City Planning Department

Memo

To: Cranston City Plan Commission
From: Joshua Berry, AICP - Senior Planner
Date: July 11, 2022
Re: “661 Park Project” - Master Plan - Major Land Development

Owner/App: Legion Development, Inc.
Location: 661 Park Ave, AP 3, Lots 289, 291, 1695 & 1696
Zone: Existing: C-3 (General Business) – Proposed: C-3 *with conditions*
FLU: Existing: Neighborhood Commercial/Services – Proposed: Mixed Plan Development

“ALTERNATE” SITE PLAN

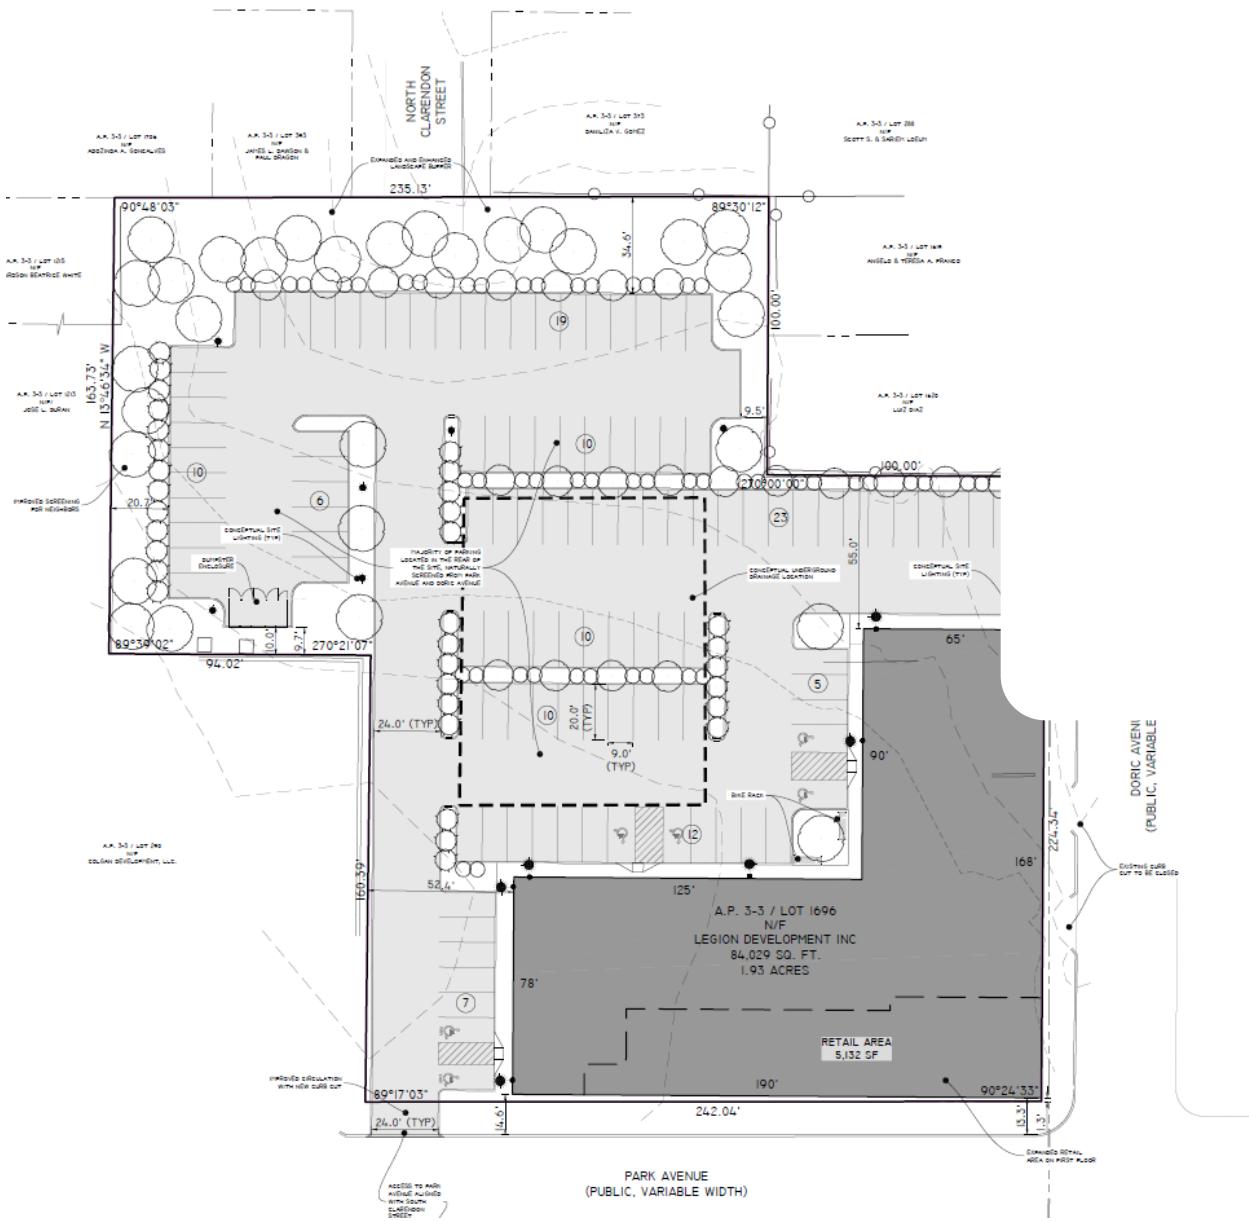
Differences from original plan:

1. North Clarendon St. emergency access is closed and additional landscaping and parking is provided.
2. Parking spaces increased from 100 to 112 spaces by reducing the parking space widths from 10' to 9' and from change #1.
